REACTOR COOLANT SYSTEM

3/4.4.6 PRESSURE/TEMPERATURE LIMITS

SUSQUEHANNA - UNIT 1

BASES FIGURE B 3/4.4.6-1

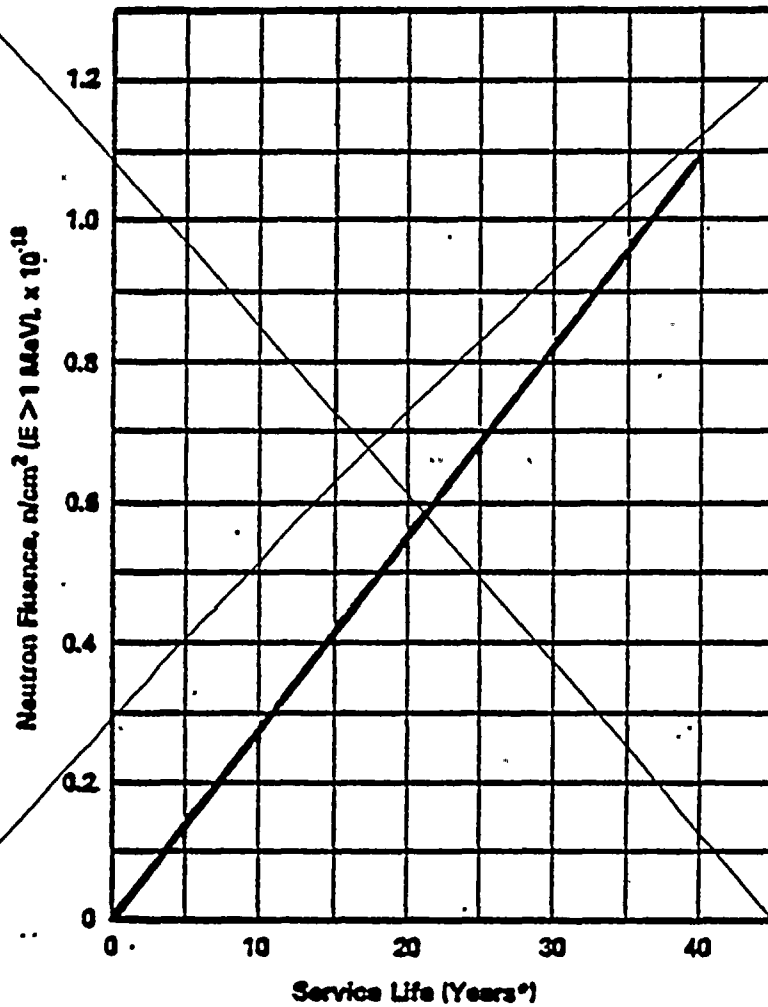
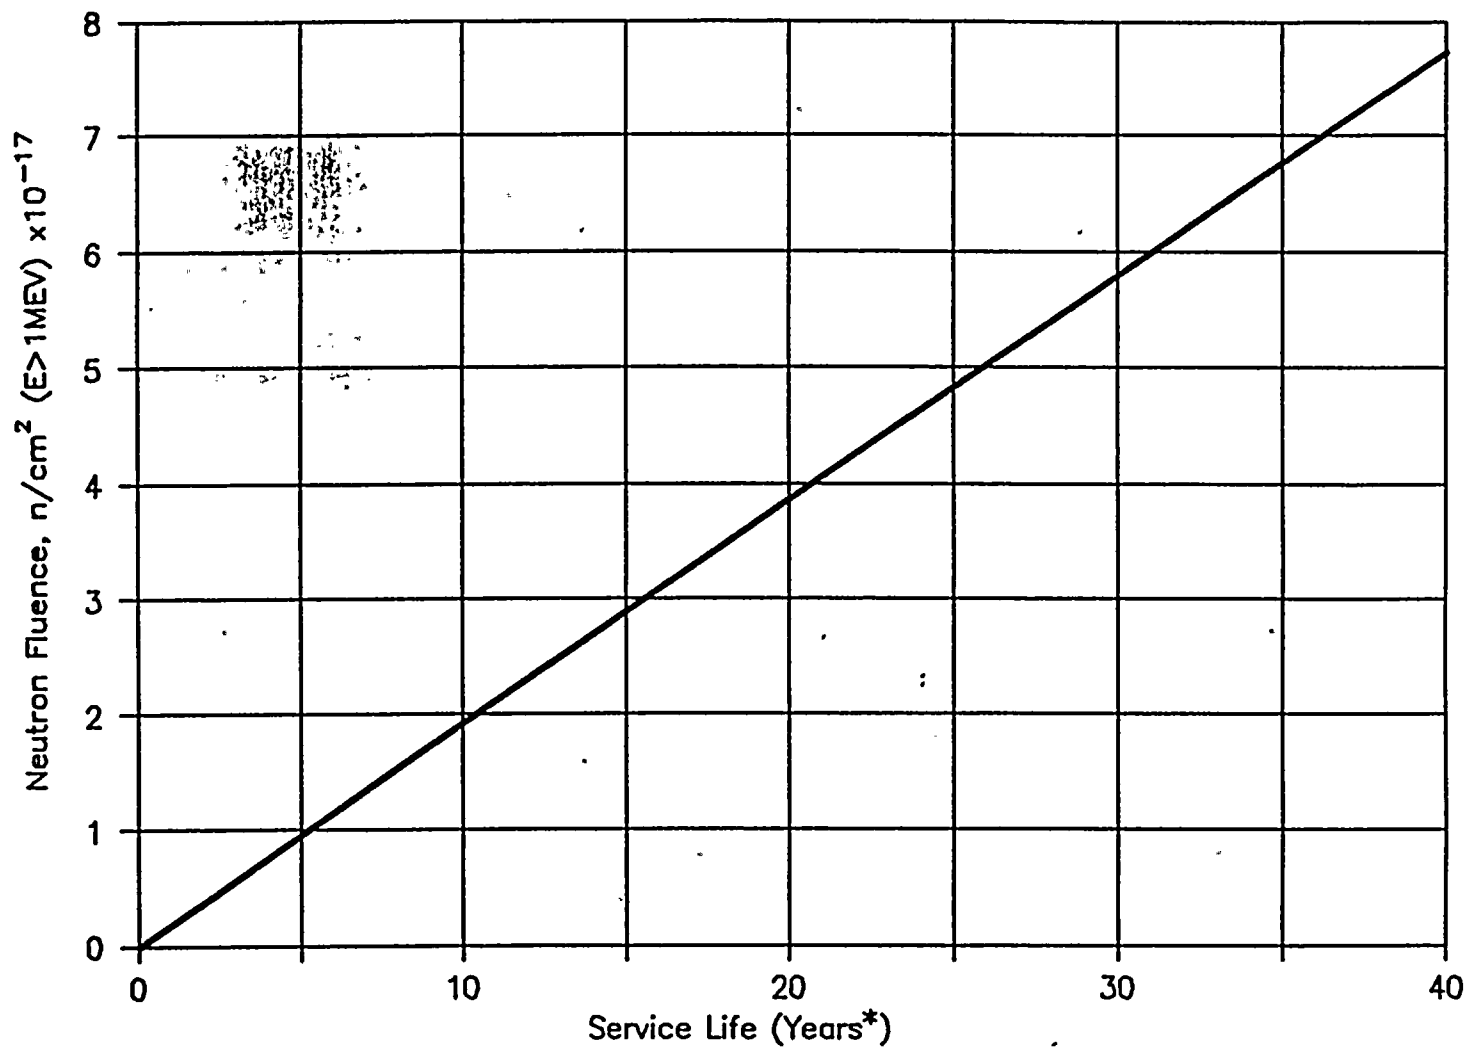
Insert New Figure

FAST NEUTRON FLUENCE (E>1 MeV) AT ½T AS A FUNCTION OF SERVICE LIFE*
